ADMINISTRATIVE AMENDMENT			
FILE #:	PROJECT #:		
APPROVED BY	DATE

LANDSCAPE PLAN AT COORS BLVD NW AND SEVEN-BAR LOOP

LANDSCAPE PLAN - MINOR AMENDMENT

Sheet: Site Plan

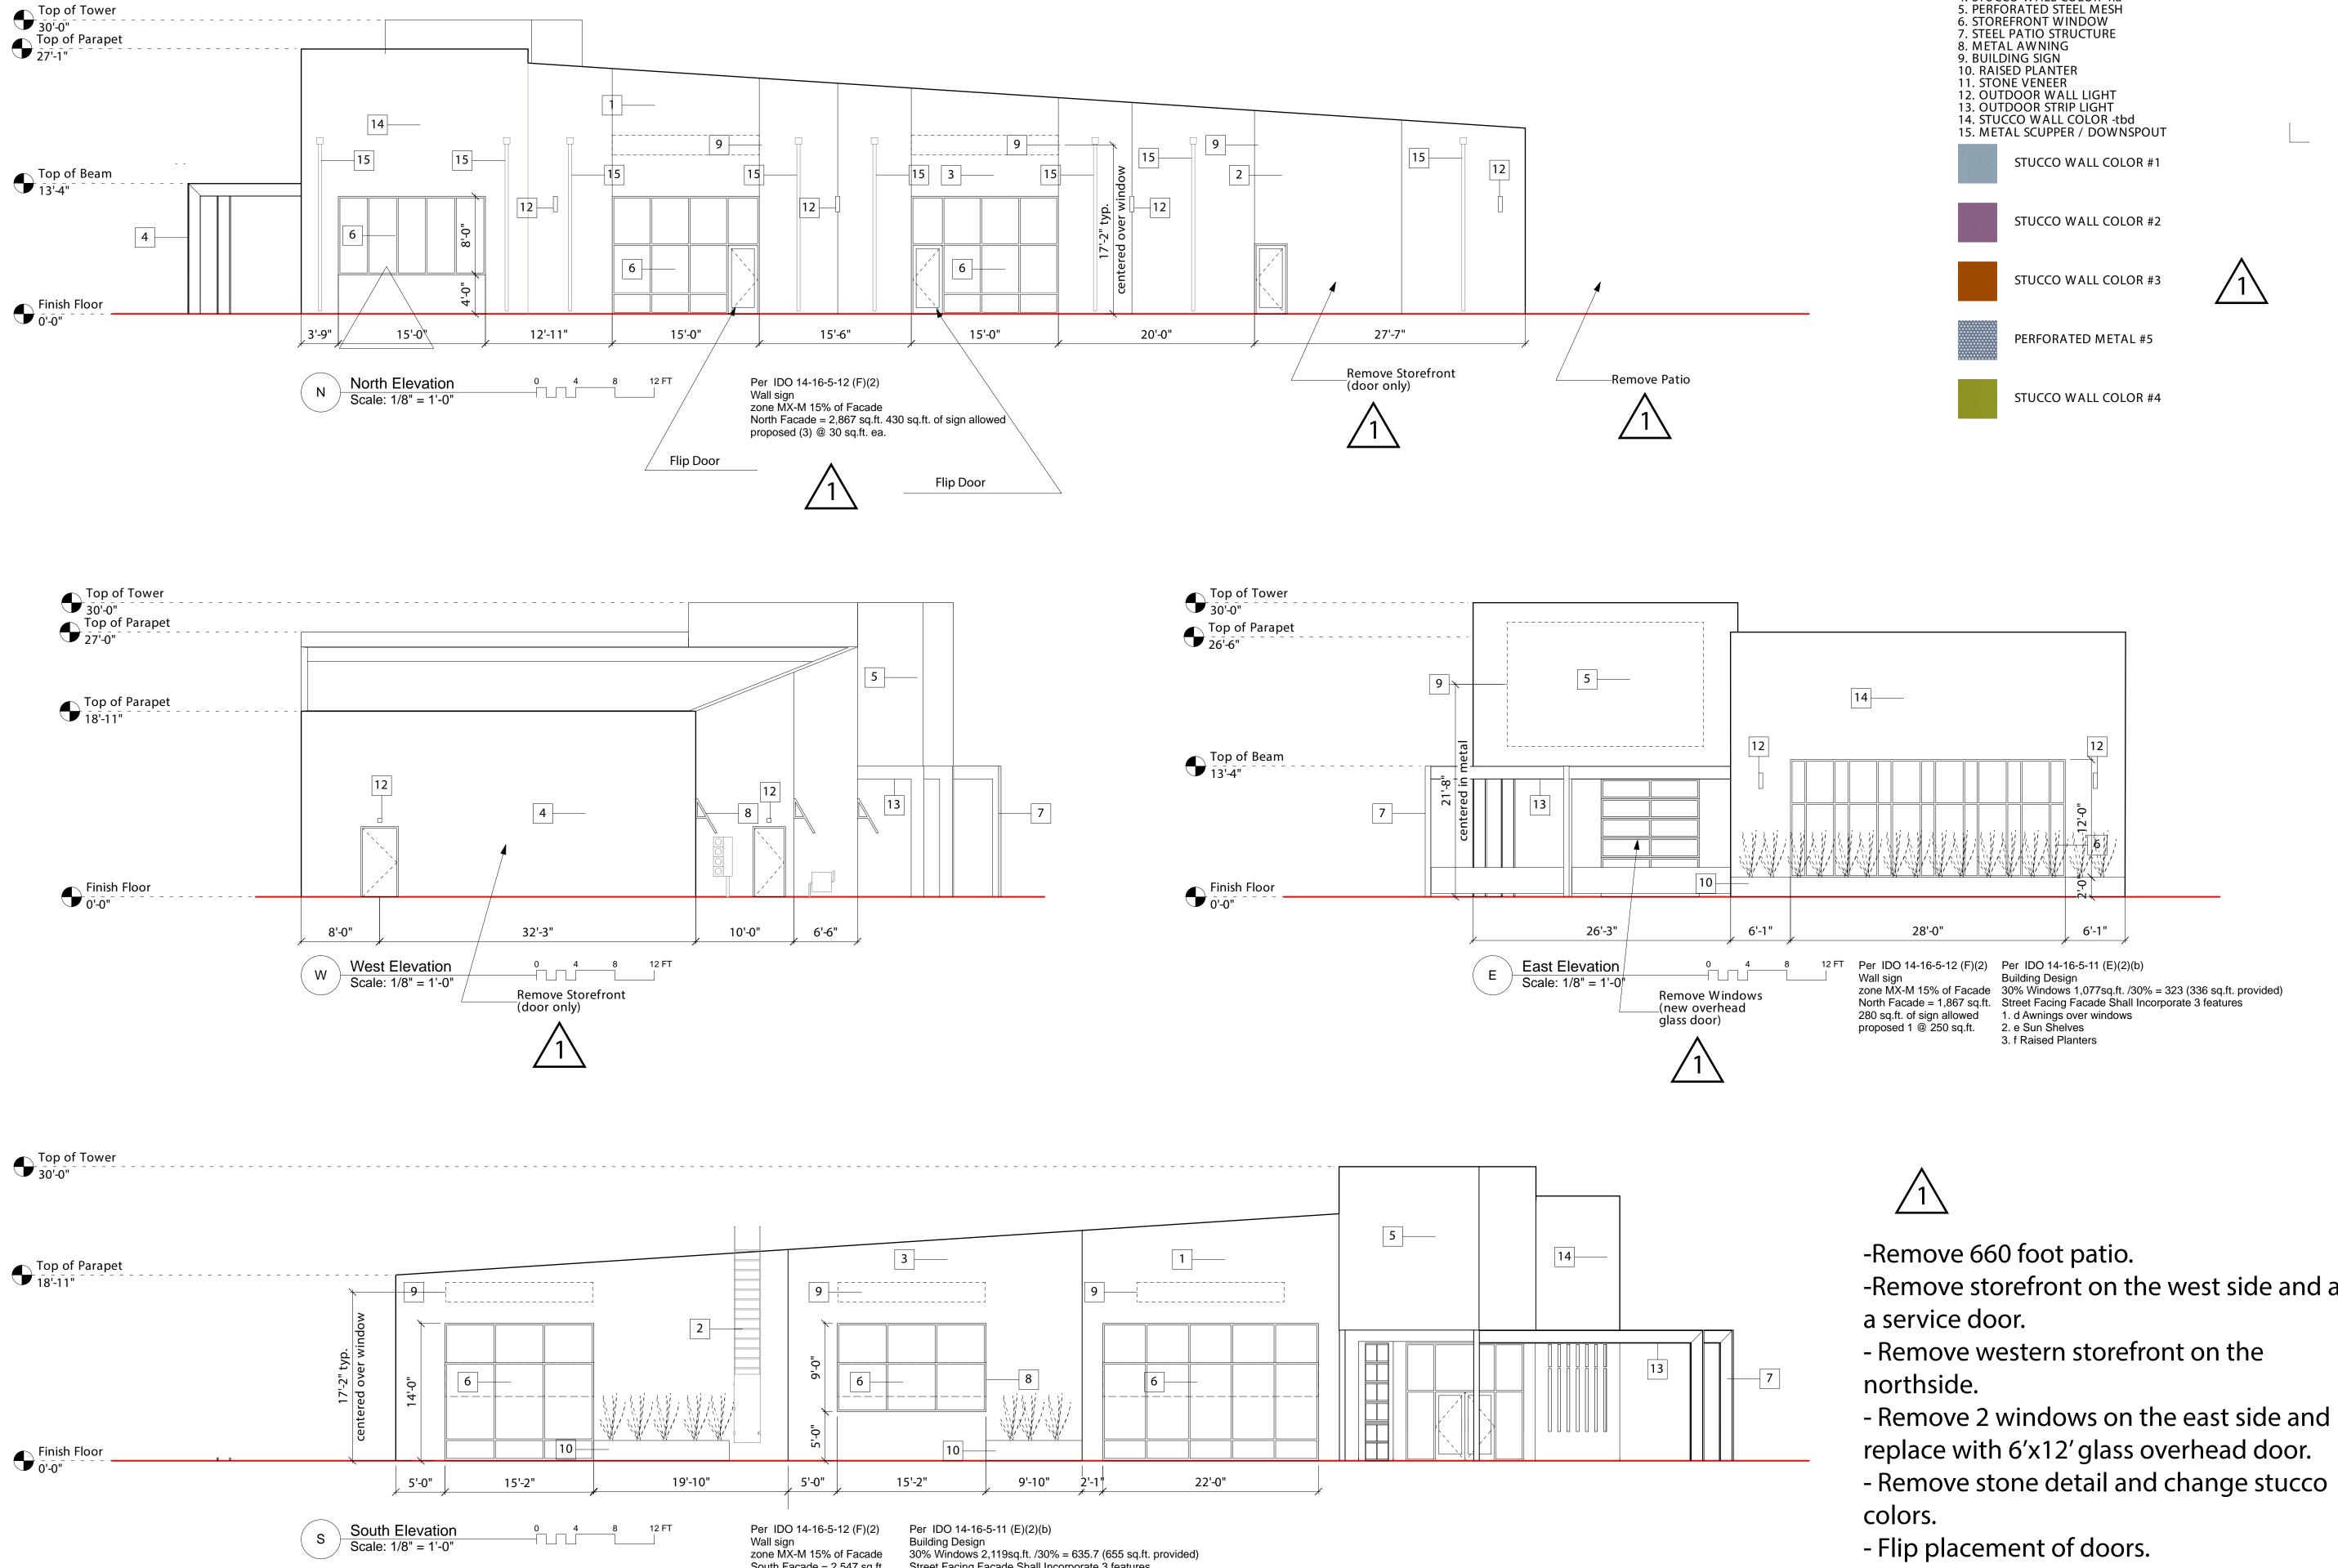
-Remove 660 foot patio.

Date: APRIL 21, 2022 Rev: 10.10.22 Sheet: Elevations

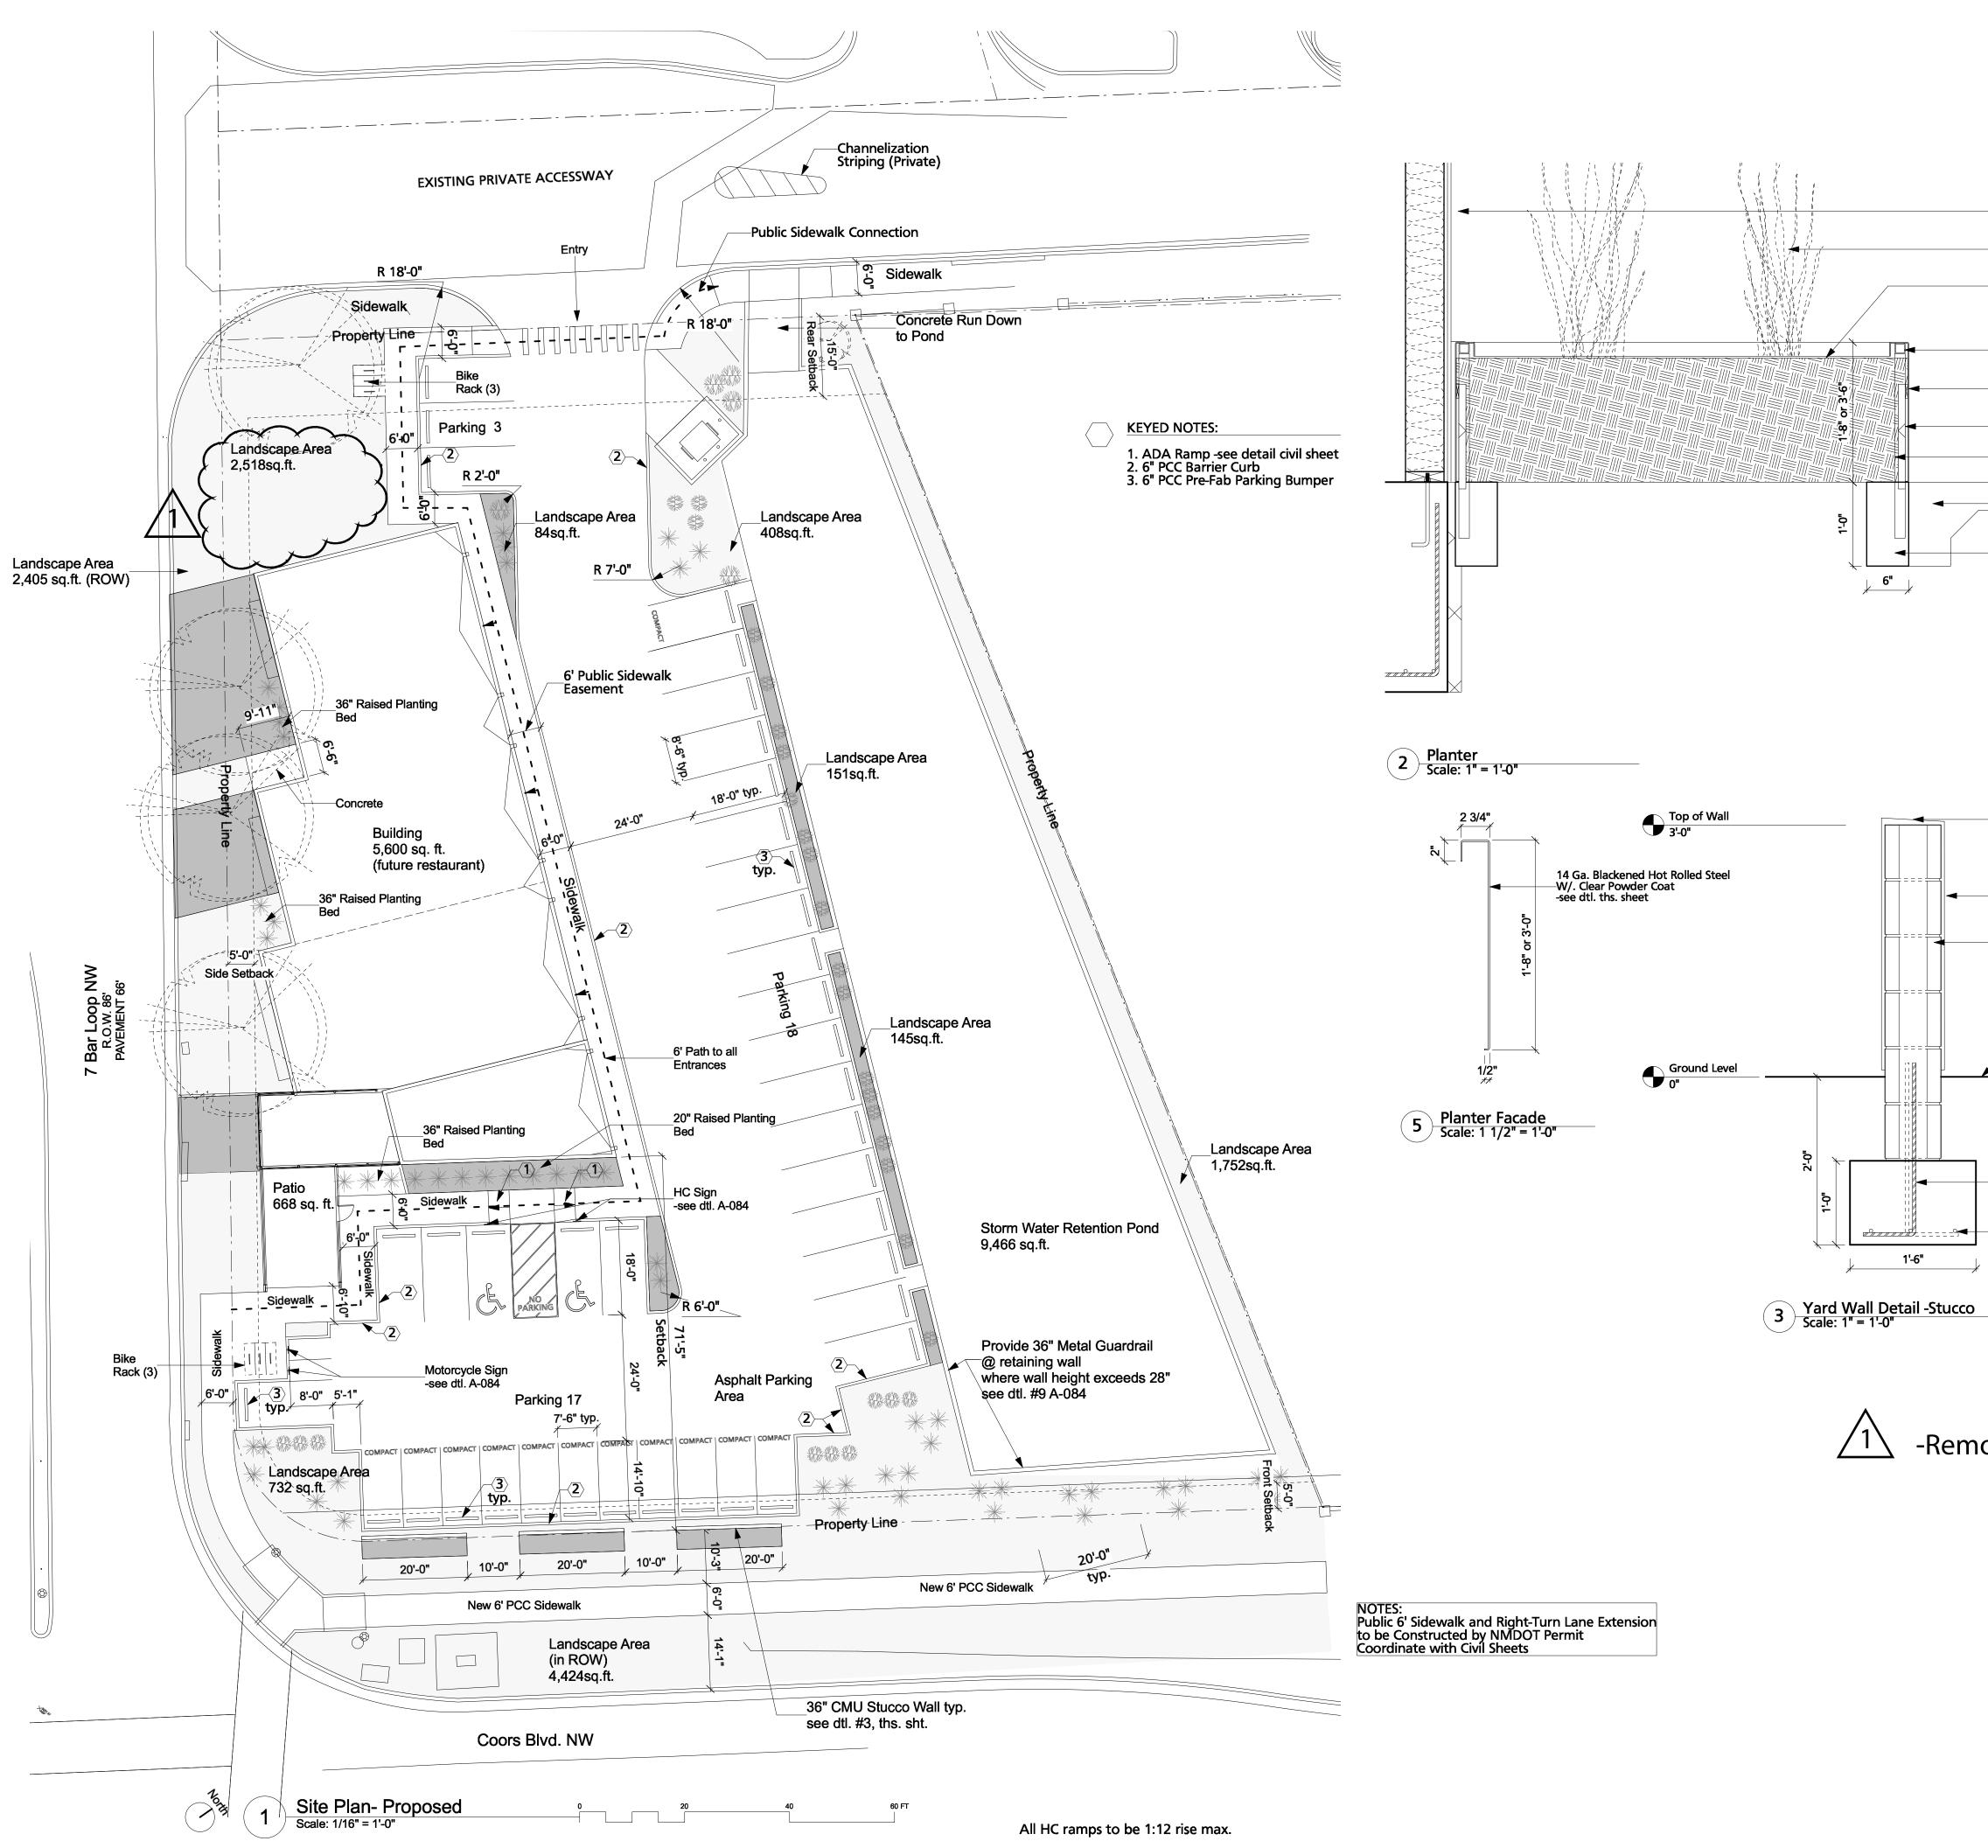
-Remove storefront on the west side and add

- Remove western storefront on the

- Remove 2 windows on the east side and replace with 6'x12' glass overhead door.

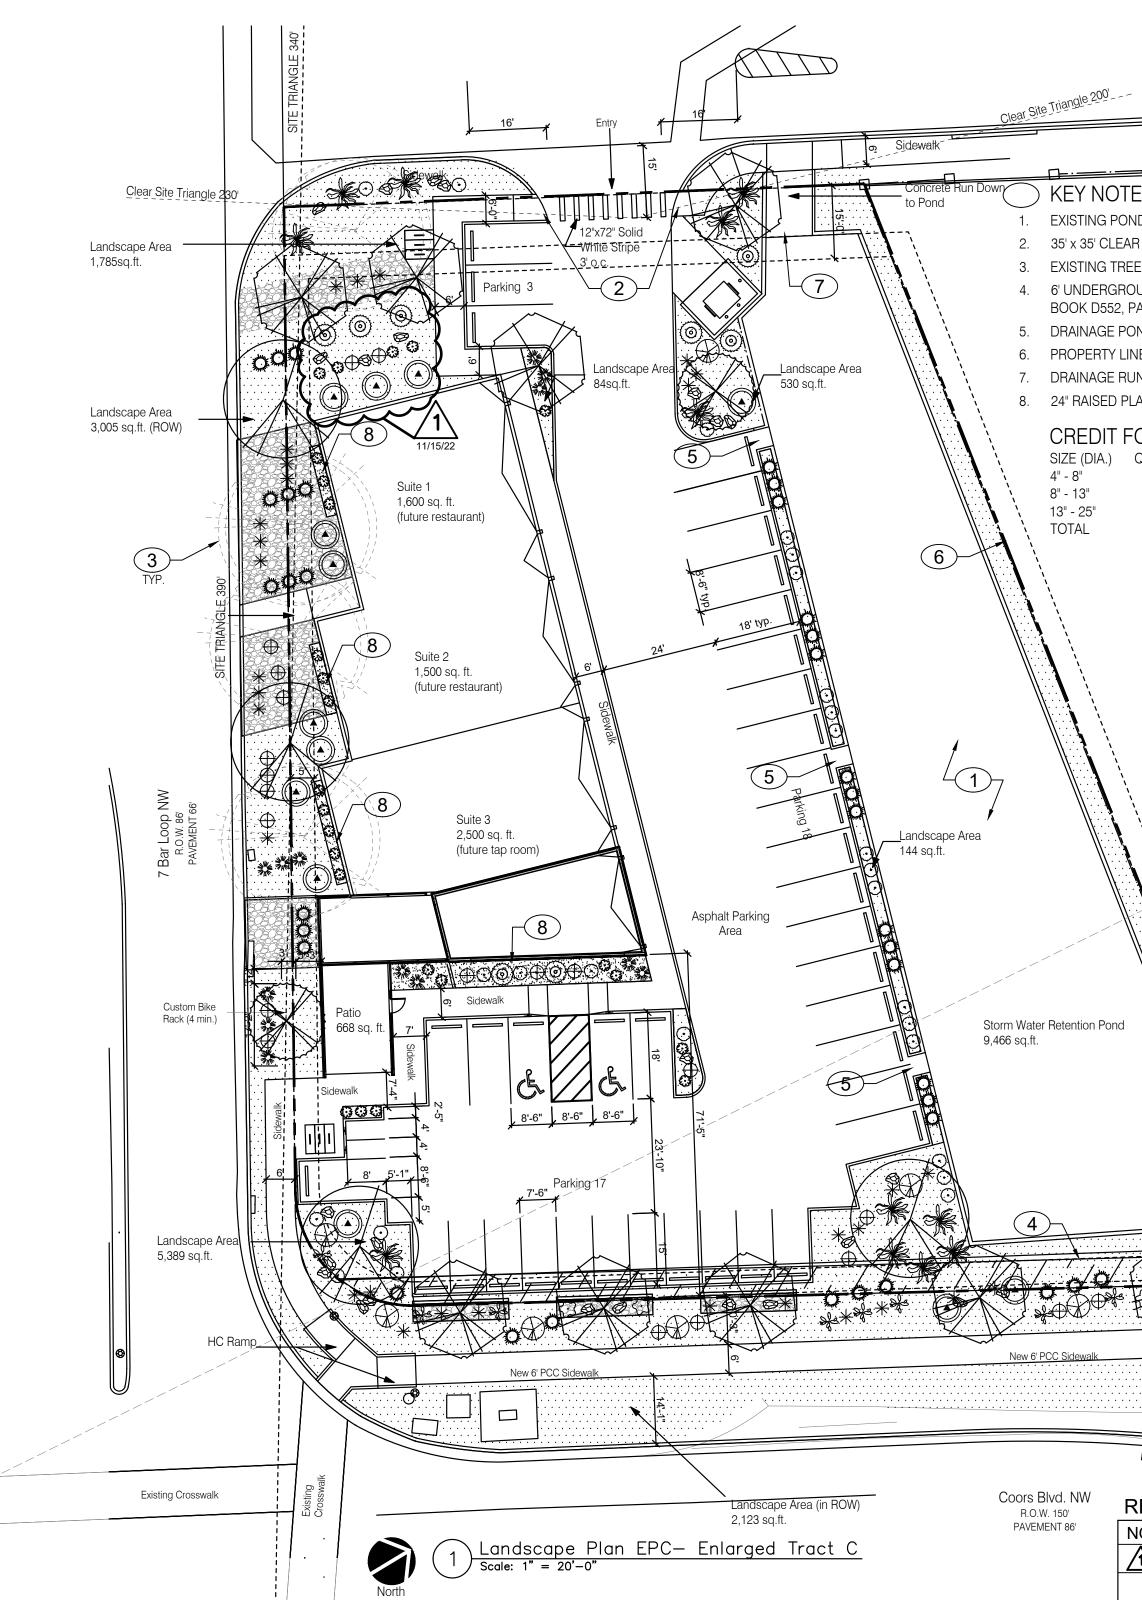
NO.	DATE	DESCRIPTION
\bigwedge	11/15/22	ADDITION OF 600 SF OF LS
